# I-25/Arapahoe Interchange Finding of No Significant Impact

February 2013

**I-25/Arapahoe Road Interchange NEPA Study  
Finding of No Significant Impact**

Figure 3. Existing and Action Alternative Cross Section - Looking East

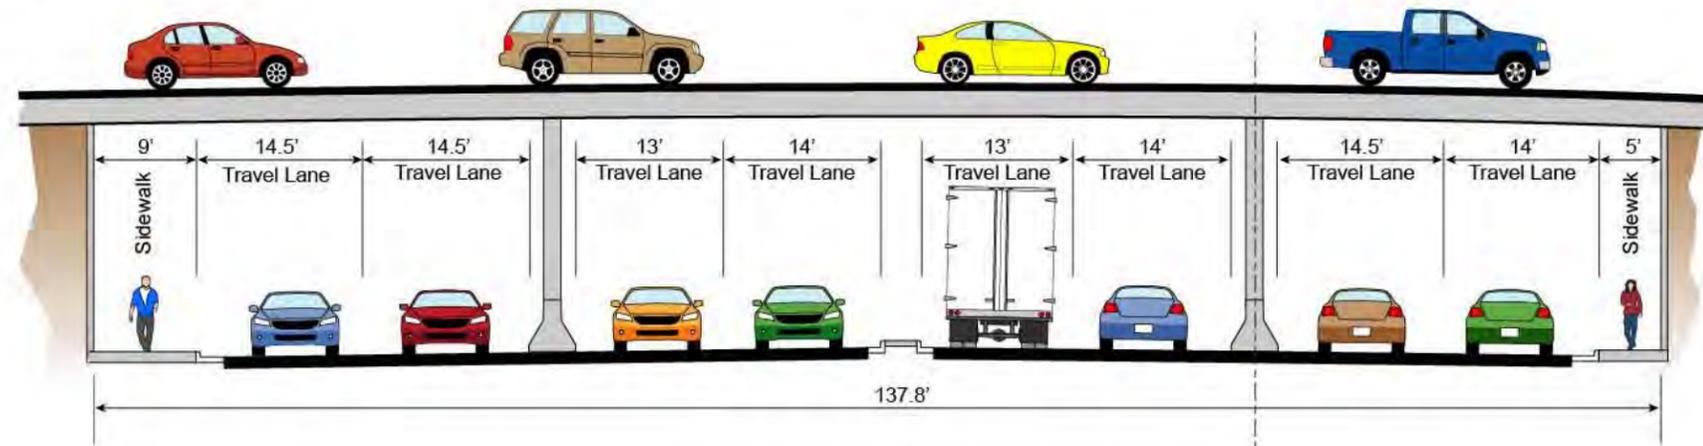
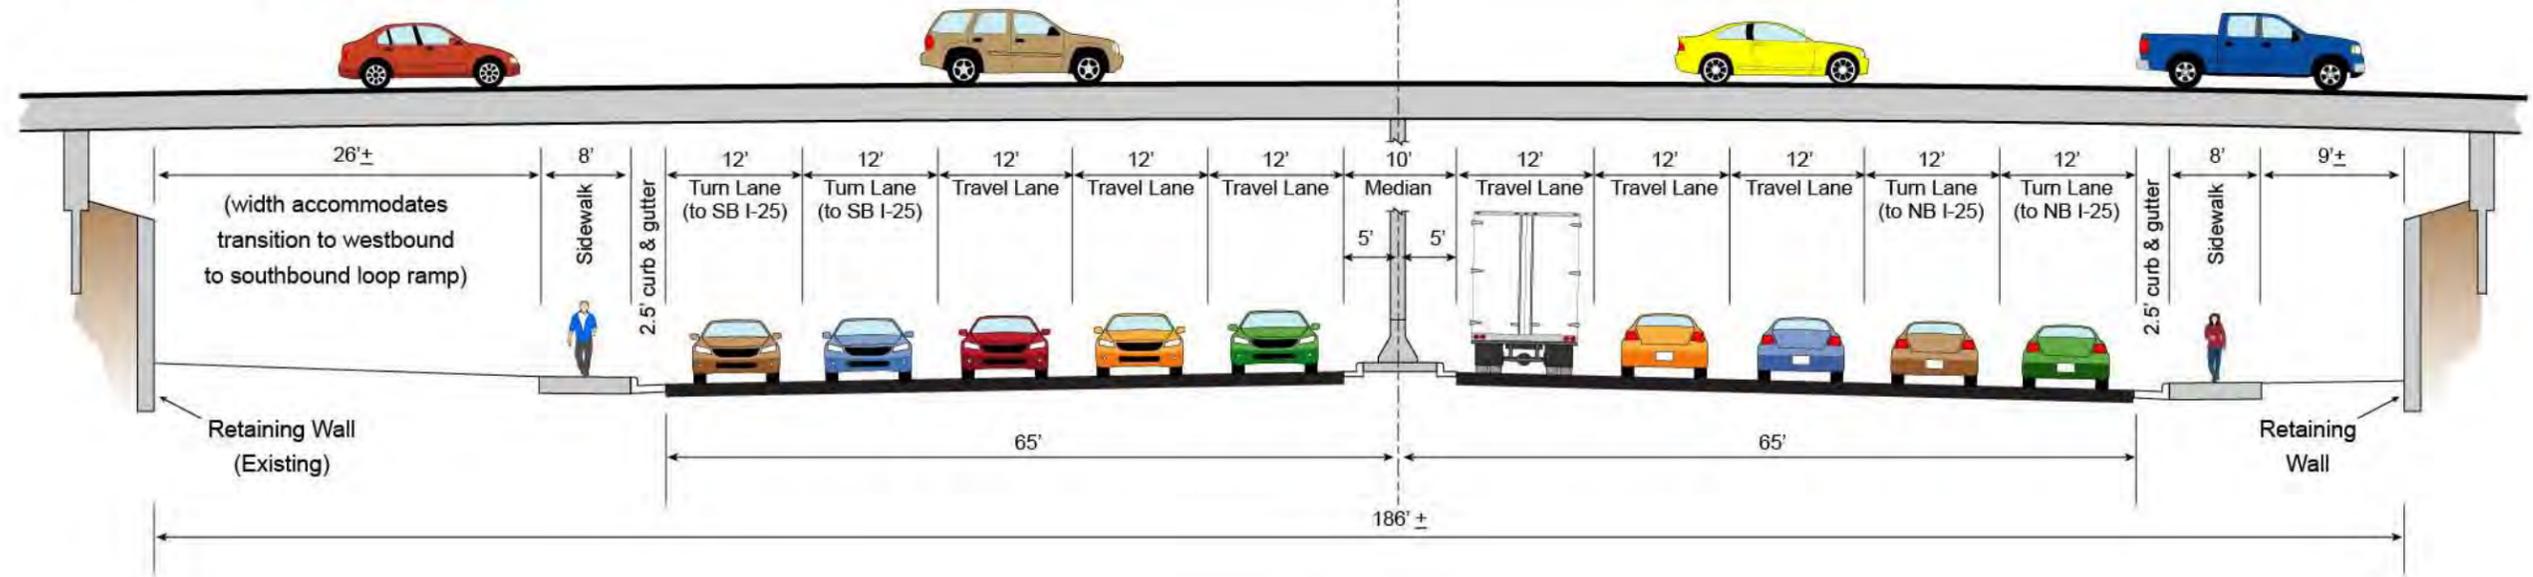
In looking at the alternatives and a couple of typical sections please make every effort to provide better pedestrian accommodations through the interchange area. The typical sections as they stand are less than ideal. I am especially concerned with the areas that are only receiving 5' sidewalks. It appears that there will be areas that will have a 5' sidewalk immediately adjacent to Arapahoe Road with a retaining wall and/or sound wall at the edge of sidewalk. With cars traveling 40-50 miles per hour on Arapahoe the 2' of sidewalk closest to the road is in essence unusable and with the wall immediately adjacent it's impossible to walk within 1.5' of the wall without chopping off an arm and shoulder so the project has in essence designed a 1' foot path of usable sidewalk. There are also cyclists that use this sidewalk to get to their destinations. Arapahoe Road is less than ideal for a cyclist but many times it is the most direct route.

**Response to W-4.** The project improves sidewalks to as great an extent as possible without taking adjacent residential property, which was determined to be a critical issue during alternatives development and conceptual design. Existing sidewalks would be reconstructed along both the north and south sides of Arapahoe Road from west of Yosemite Street, through the interchange, to east of Boston/Clinton Street. Sidewalk widths would vary from 8 to 10 feet in the project area. All attempts will be made to maximize sidewalk width and construct detached sidewalks where reasonable within available ROW. However, 5-foot sidewalk segments may be utilized along Arapahoe Road west of Yosemite Street and along Yosemite Street south of Arapahoe Road where a commitment was made to avoid residential property acquisition. Maximizing sidewalk width within the available ROW will be considered again during final design.
